UNITED STATES PATENT AND TRADEMARK OFFICE

APPLICATION NO.	FILING DATE	FIRST NAMED INVENTOR	ATTORNEY DOCKET NO.	CONFIRMATION NO.
10/807,195	03/24/2004	Sotaro Tsukamoto	SON-2982	3711
23353	7590	04/21/2005	EXAMINER	
RADER FISHMAN & GRAUER PLLC LION BUILDING 1233 20TH STREET N.W., SUITE 501 WASHINGTON, DC 20036				MAGEE, THOMAS J
ART UNIT		PAPER NUMBER		
		2811

Office Action Summary	Application No.	Applicant(s)	
	10/807,195	TSUKAMOTO ET AL.	
	Examiner Thomas J. Magee	Art Unit 2811

DETAILED ACTION

Appended Marked-up figure 2. BEST AVAILABLE COPY

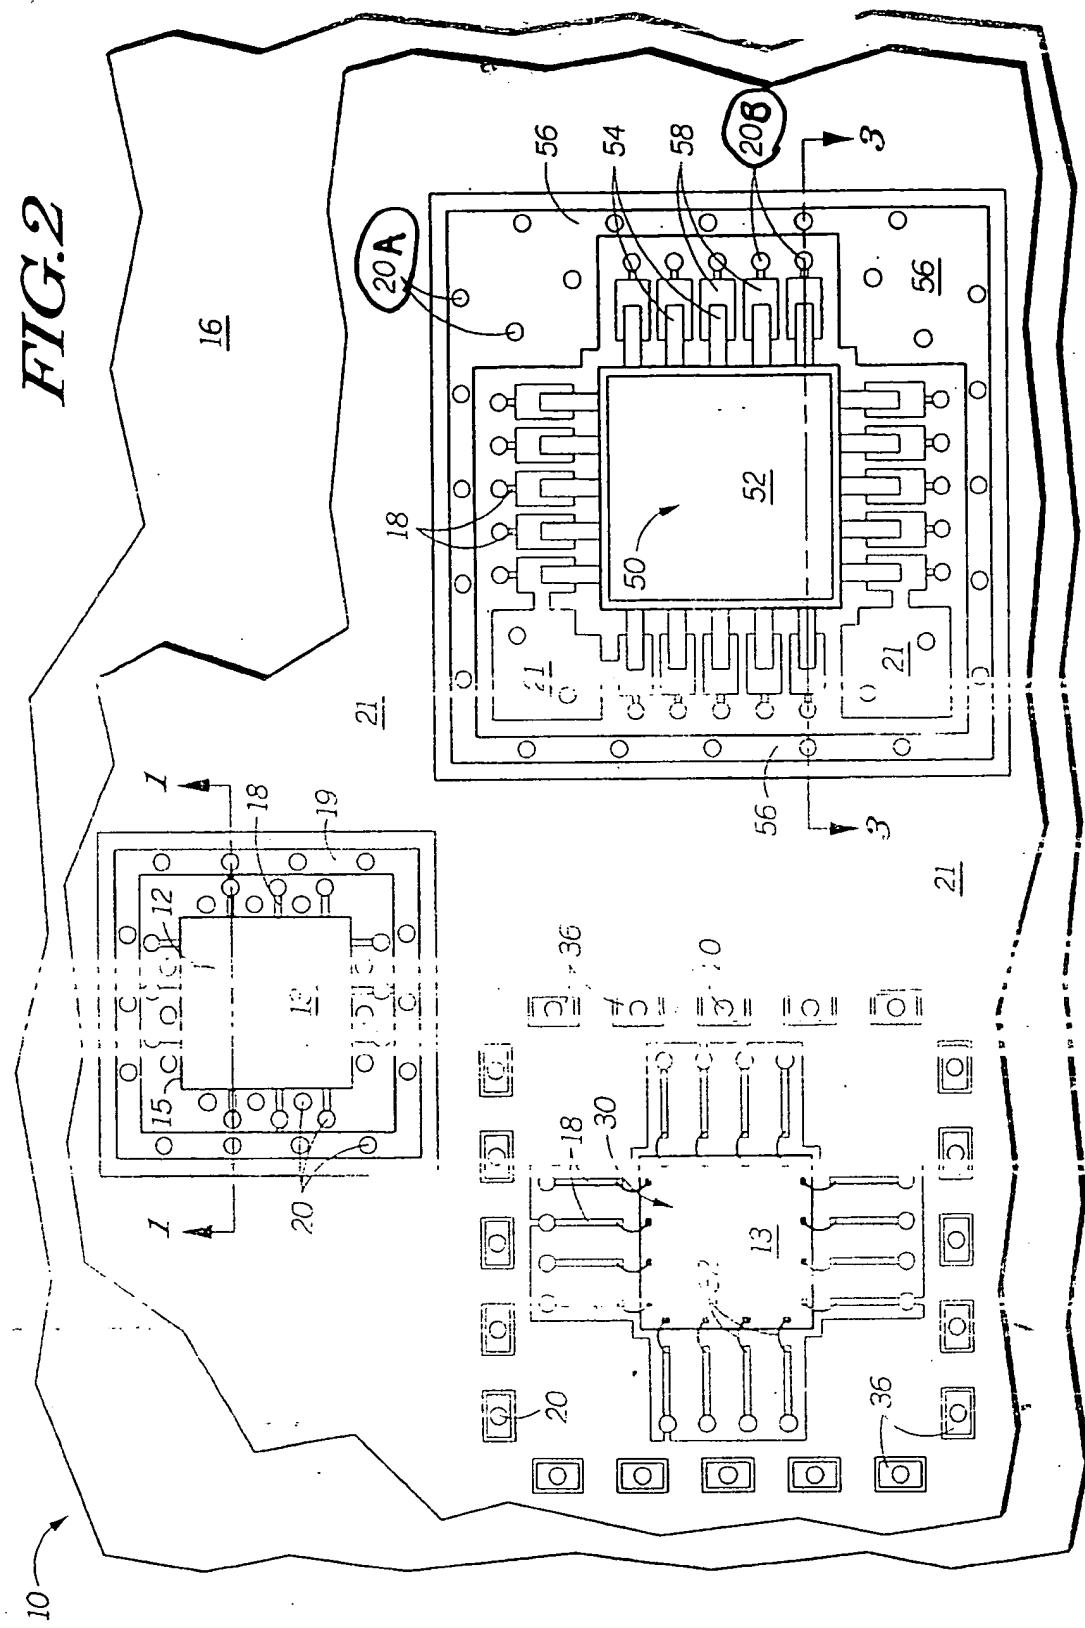
at least one bare semiconductor integrated circuit device (13) (right hand side) (Figure 2),

a plurality of shield interlayer-connection conductor films (20A) (Appended Marked-up Figure 2) that are provided so as to surround the semiconductor integrated circuit device and that provide electrical connections between the first shield wiring film and the second shield wiring film (20A) (Appended Marked-up Figure 3)

Appended Marked-up Figure 3 BEST AVAILABLE COPY

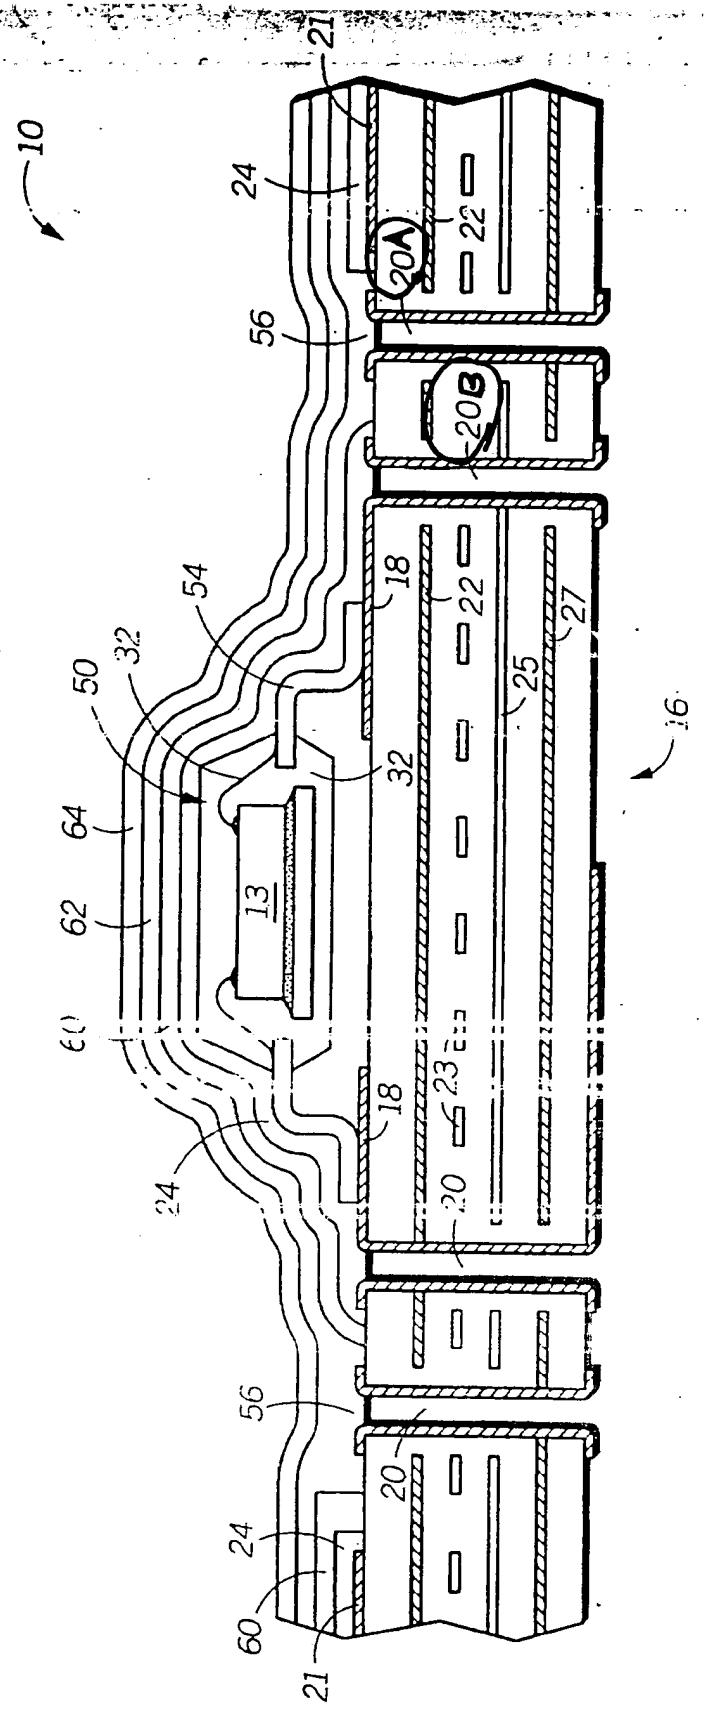
interlayer insulating films (24, 16) (Figure 3),

multilayer wiring films (horizontal section of 18, 22, 25), each being provided at one of the interlayer insulating films or between two of the interlayer insulating films,

interlayer-connection conductor films (20B) (Appended Marked-up Figure 3) each extending through at least one of the interlayer insulating films and providing an electrical connection between at least two of the interlayer insulating films,

a first shield wiring film (60) (Figure 3) provided above the semiconductor integrated circuit device and a second shield wiring film (27) (Col. 7, lines 56 – 61) provided below the semiconductor integrated circuit device, and

each shield interlayer-connection conductor film extending through at least one of the interlayer insulating films (See Figure 3).
